Allen Pump
Chas G Allen Inc
25 Williamsville Road
Barre, MA 01005
Tel 978-355-2911
Fax 978-355-2917
March 2, 2018

Large Power Plant
123 Power Road
New England

Re: Unit 1-B Main Boiler Feed Pump Rotor Inspection
Ingersoll-Rand M/N 5CHTA

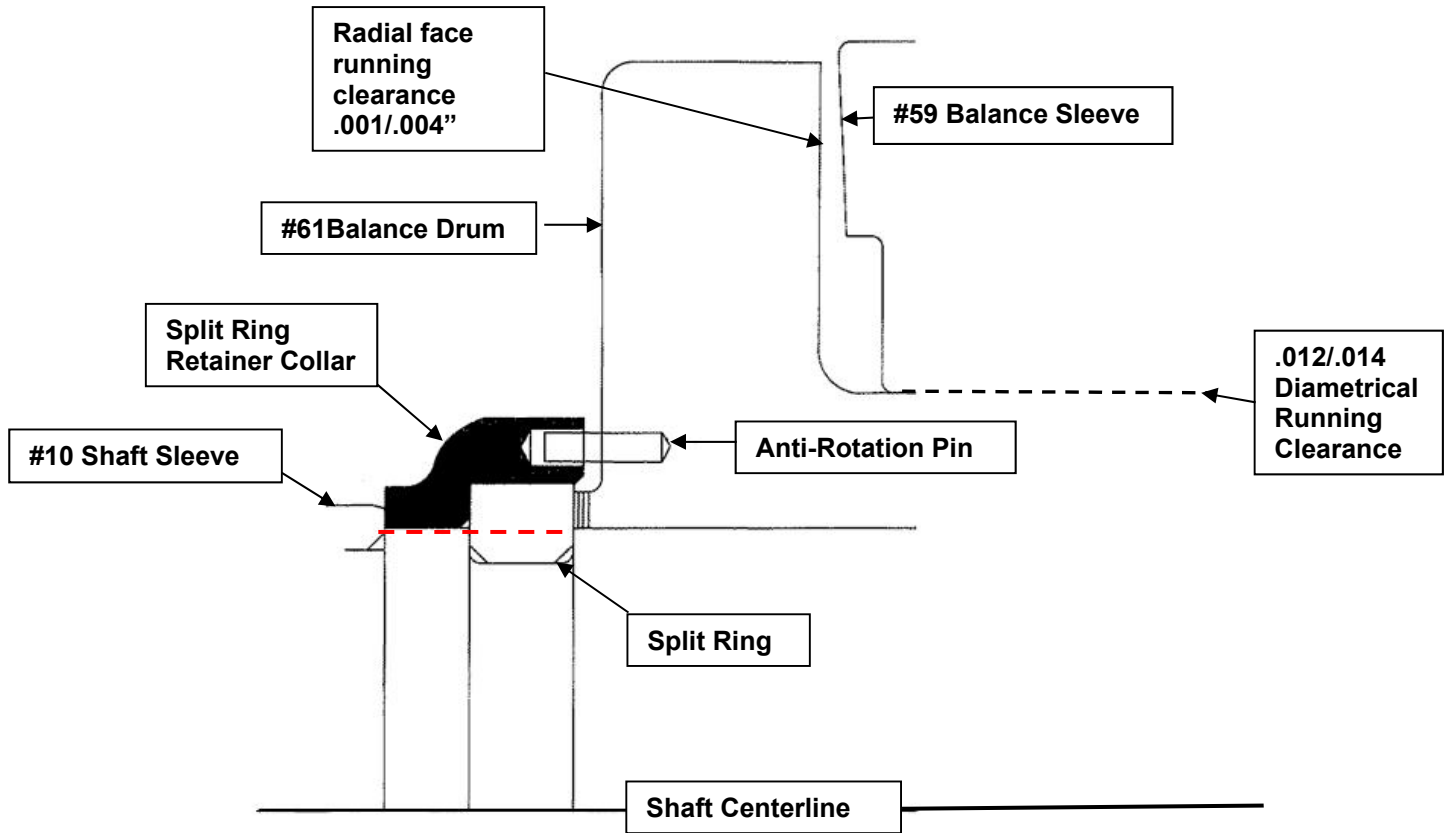
Old style threaded shaft design for retaining and adjusting the rotor centralization. Threads are damage and signs of water cutting under the drum

Newer design utilizes a split ring and retainer collar with an interference fit to the shaft as shown on the next page

Provide a new shaft with the following upgrade eliminating the shaft threads
